Reddy Residence
3737 W. Ruby Hill Drive
Lot O-02

Side-by-side Comparison of
Approved Plans and As-built
Condition

COLUMNS AT AUTO COURT

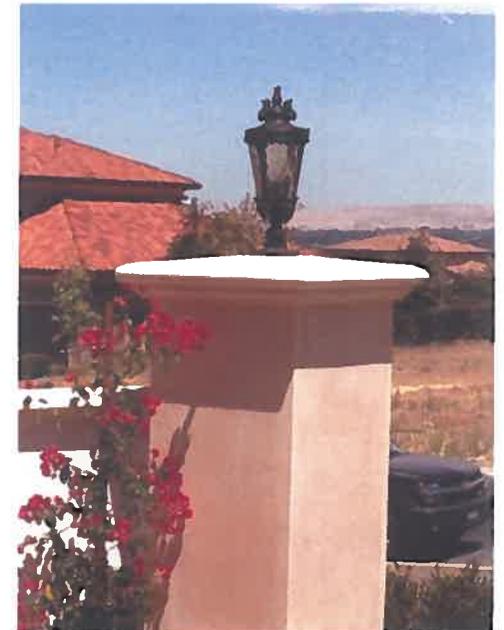
Columns depicted on final approved drawings (6.30.10). Height shown at 56".

As-built condition. ADC approved variance of max height of 60". Column measures 68" from grade, w/14" light fixture on top.

SWINGING DOORS FACING STREET AT LANAI (GARAGE)

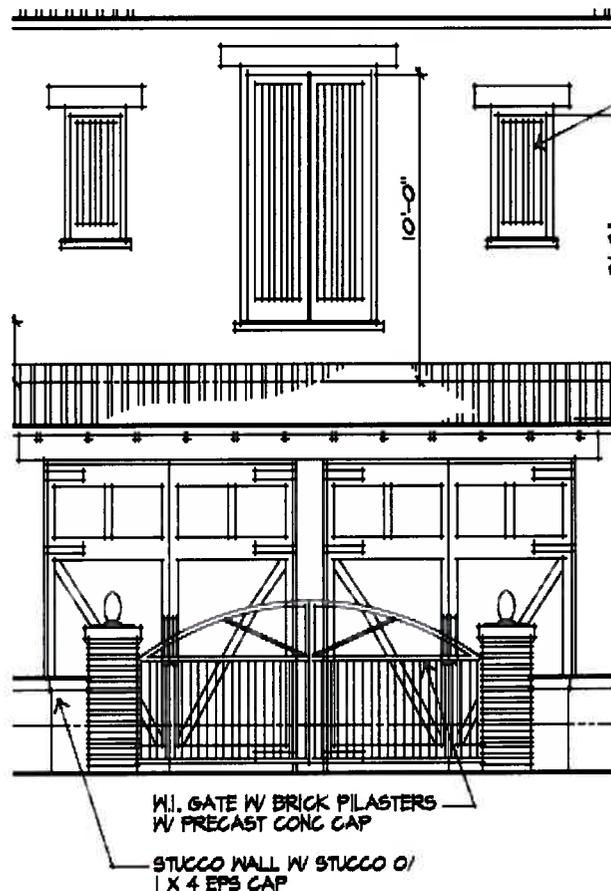
Garage depicted on final approved drawings (6.30.10) – Doors are simple, solid wood to match adjacent garage doors.

As-built condition. Original garage space converted to a “lanai”. Lanai concept not approved – space must remain a garage. Glass is not allowed in garage doors. Iron work and gold accenting is too ornate and would not be approved if submitted.

SWINGING DOORS FACING STREET AT GARAGE

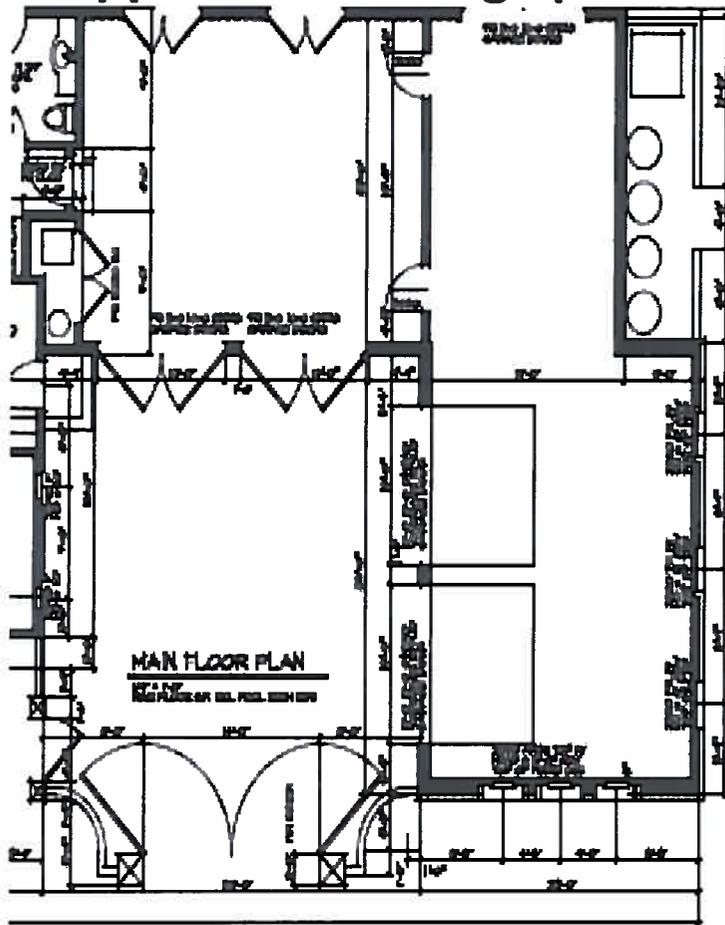
Floor plan of garage depicted on final approved drawings (6.30.10).

As-built condition. Original garage space converted to a "lanai". Lanai concept not approved – space must remain a garage. Glass is not allowed in garage doors. Iron work and gold accenting is too ornate and would not be approved if submitted.

FRONT ENTRY DOORS

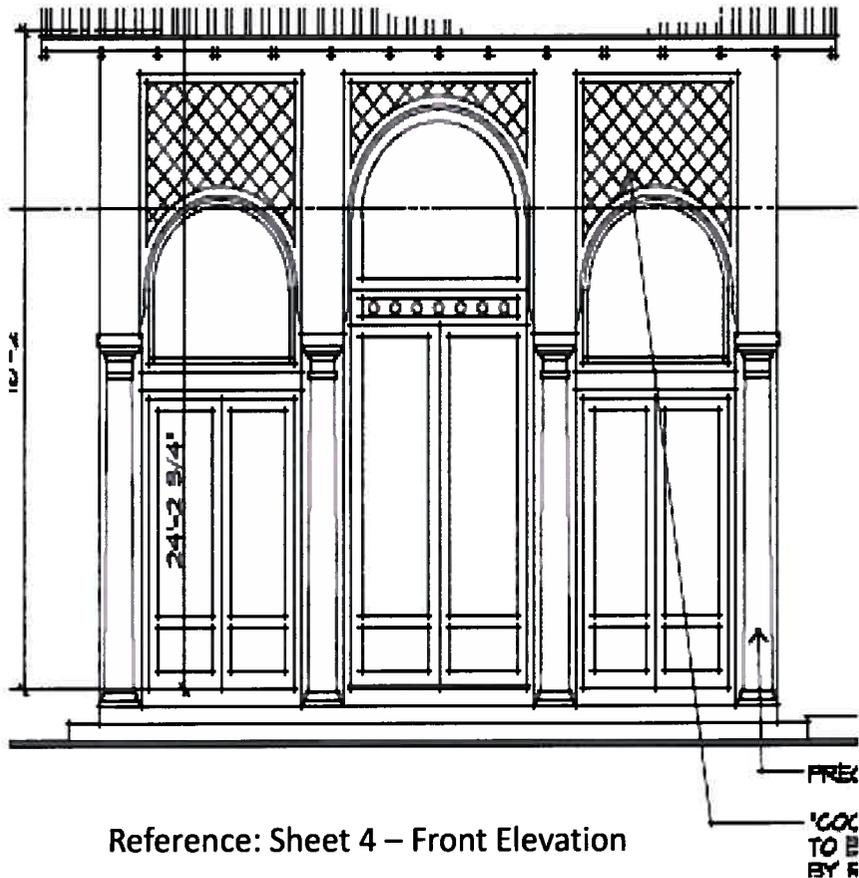
Front entry doors depicted on final approved drawings (6.30.10)

- Wood panel doors without glass or iron work
- Simple Arched transom windows above

As-built condition:

- Iron frame w/glass inserts
- Overly ornate ironwork with gold accent for both door and transom above

FRONT ENTRY DOORS

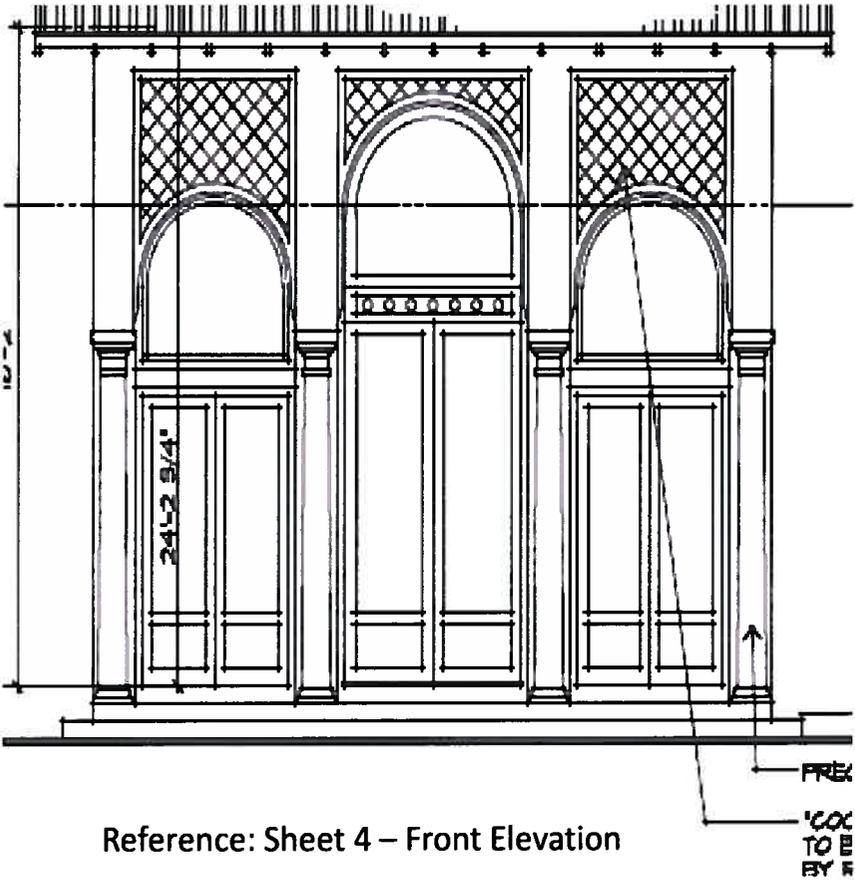
Front entry doors depicted on final approved drawings (6.30.10)

- Wood panel doors without glass or iron work
- Simple Arched transom windows above

- As-built condition:
- Iron frame w/glass inserts
 - Overly ornate ironwork with gold accent for both door and transom above

HORIZONTAL BAND AT FRONT ELEVATION

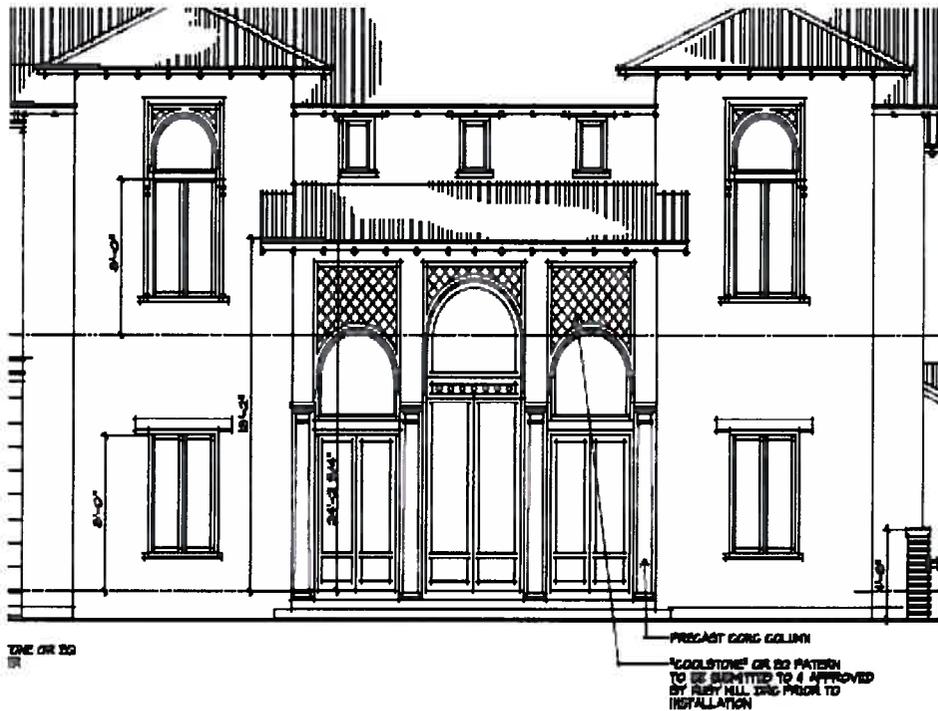
Front elevation depicted on final approved drawings (6.30.10). Void of any horizontal trim work

As-built condition. Horizontal banding added without approval. ADC will accept the added trim work under the condition that it is painted to match the approved body color.

PRECAST COLUMNS

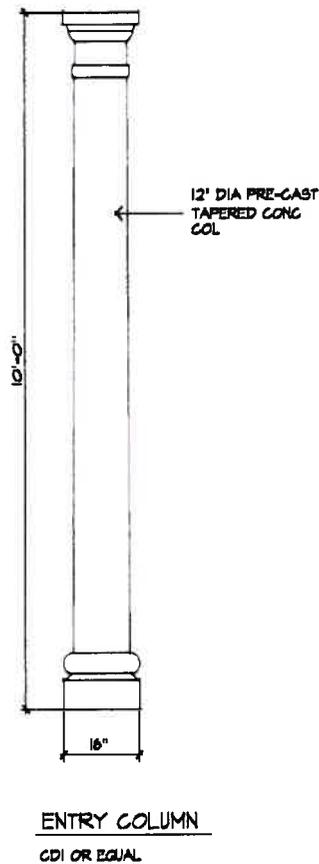
Column elevation depicted on final approved drawings (6.30.10). Simple Tuscan capital

As-built condition. Design is inconsistent with the Spanish Eclectic architectural style.

STUCCO WALL AT MASTER SUITE

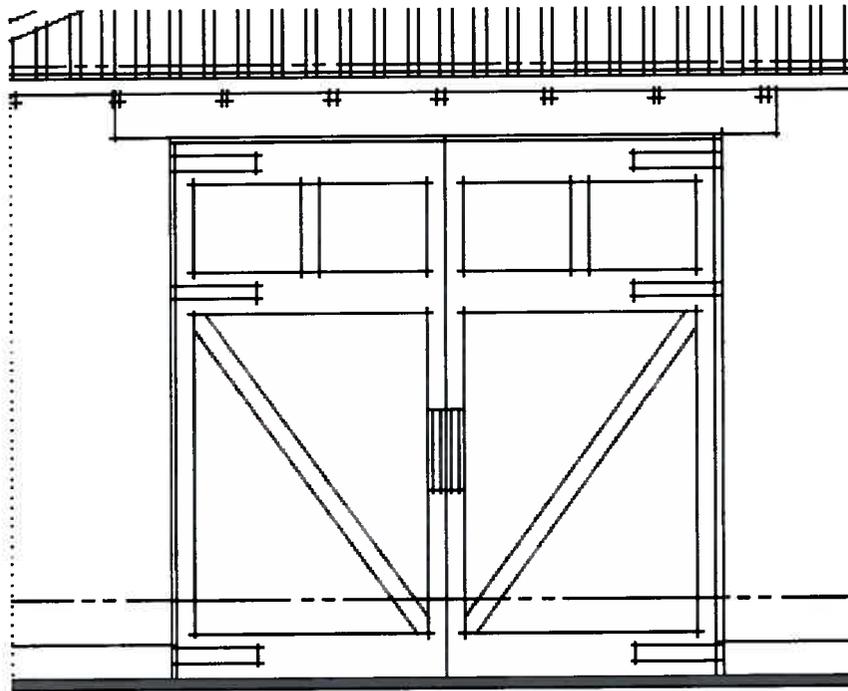
Color at back wall of master bedroom suite appears unfinished. Must be painted to match the approved body color.

GAZEBO

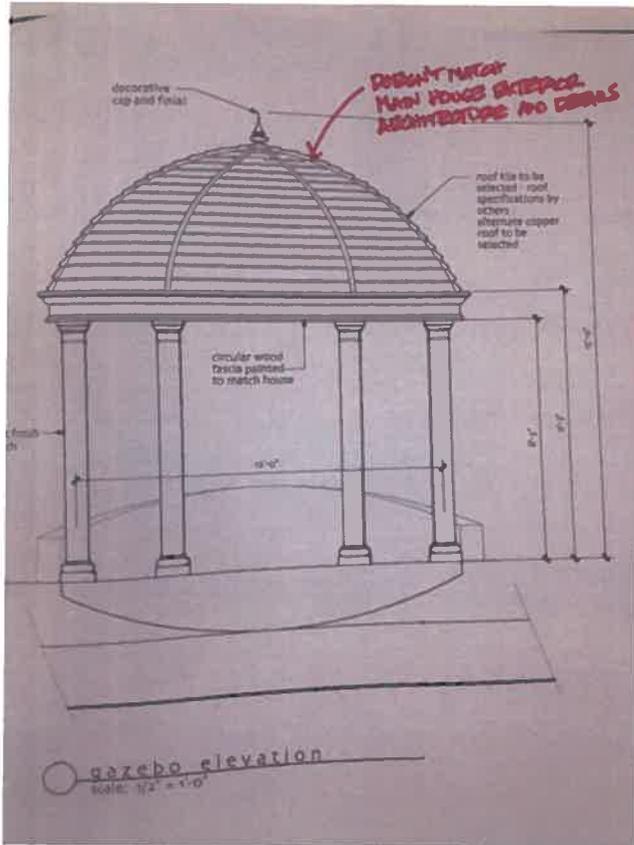
Original gazebo design submitted (8.20.10) – NOT APPROVED

Photo of proposed gazebo submitted to the ADC by Reddy on 4.12.11

As-built condition:

- Owner proceeding with construction of gazebo without approval from the ADC or required permits from the City of Pleasanton.
- Original comments from ADC specified that gazebo columns must match final approved columns of the house.
- The iron work submitted in the proposed illustration (4.12.11) was not approved and will not be approved – it is too ornate and is inconsistent with the architectural style of the home.
- The height of the proposed dome exceeds the maximum height limit for a shade structure and accessory structure.
